CHAPTER 2.0: RECOMMENDED PROJECT DESCRIPTION

2.2 RECOMMENDED PROJECT DESCRIPTION

APPENDIX C
BART EXTENSION PROJECT PRELIMINARY ENGINEERING PLANS AND PROFILES
INDEX OF DRAWINGS

Figure 2.2-5: Design Changes In Santa Clara

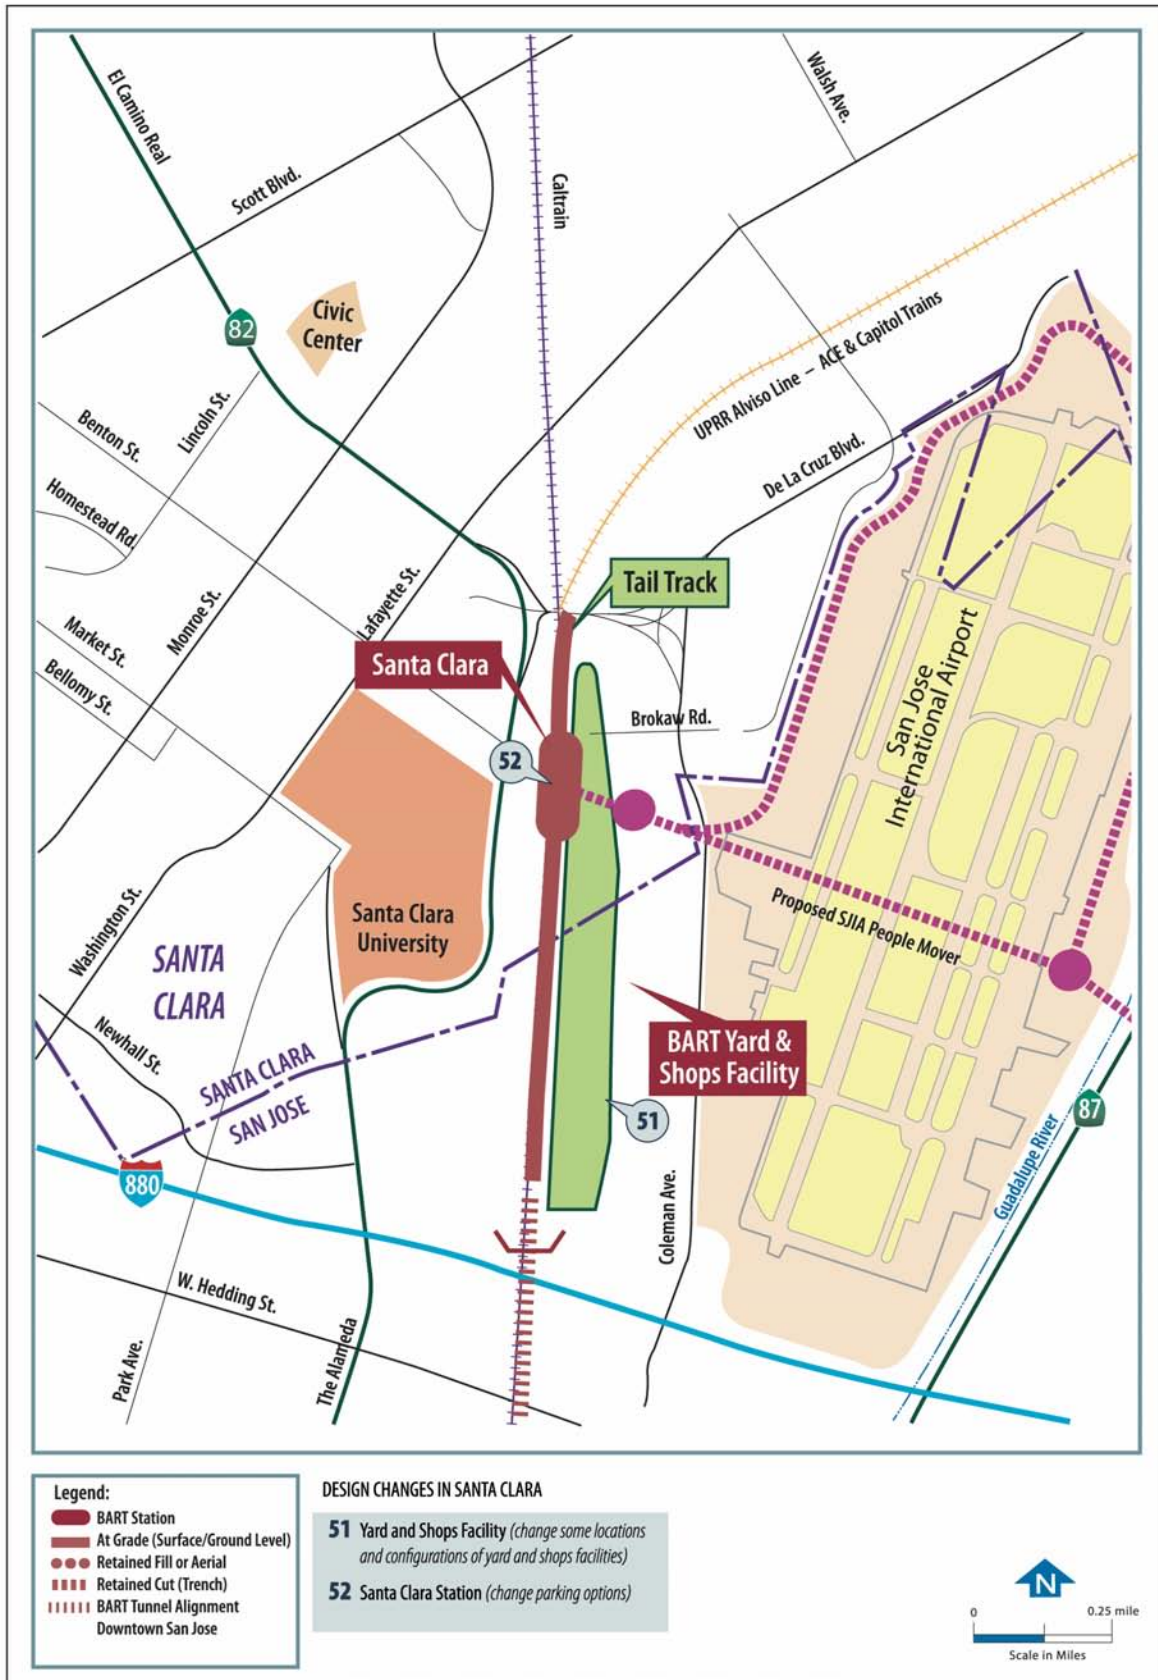
The BART Extension Project in Santa Clara is shown on Figure 2.2-5. The yard and shops facility would begin north of the west tunnel portal at Newhall Street and extend to De La Cruz Boulevard, where a single tail track would go under the De La Cruz Avenue overpass and terminate on the other side of the overpass. The facility would be long and narrow, encompassing approximately 69 acres, and would be constructed on the former UPRR Newhall Yard (purchased by VTA in 2004). The facility would displace the western portion of the Food Machinery Corporation (FMC) manufacturing facility (owned by City of San Jose). The tail track alignment would require some property acquisition from a site currently leased by Federal Express and the relocation of two cellular towers. The main entrance to the facility would be from Newhall Drive. Other secured entrances would be provided at various locations for employees and emergency personnel. The site would include service roads to all buildings on site along with provisions for approximately 470 parking spaces for employees, authorized visitors, and delivery and service vehicles.
